UNITED STATES PATENT AND TRADEMARK OFFICE

10/787,076

Office Action Summary

DETAILED ACTION

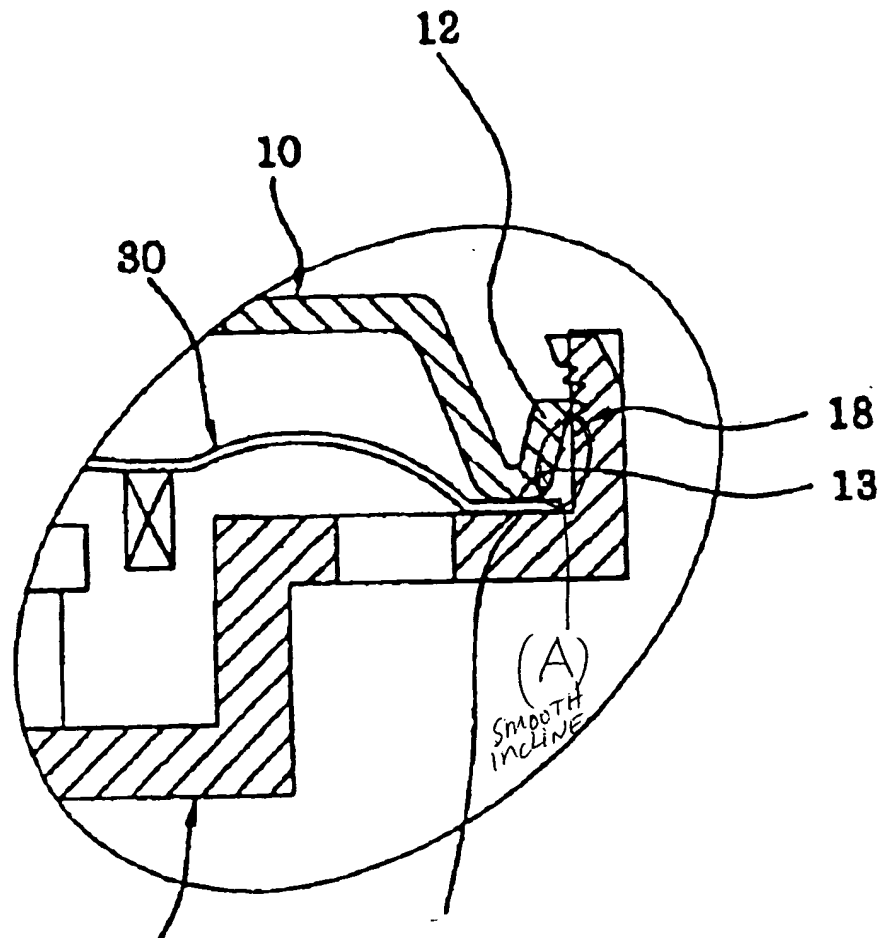
A protrusion **12** provided on the peripheral wall portions of the cover member, reading on "provided on the other of the peripheral wall portions of the frame and the cover member for being inserted in said hole",

Wherein the protrusion **12** (see figure, below, provided by the Examiner) has a smoothly inclined surface **(A)** to guide the protrusion into the hole **18** so that the protrusion **12** is inserted in the hole smoothly to fix the frame **20** and the cover member **10**, as claimed.
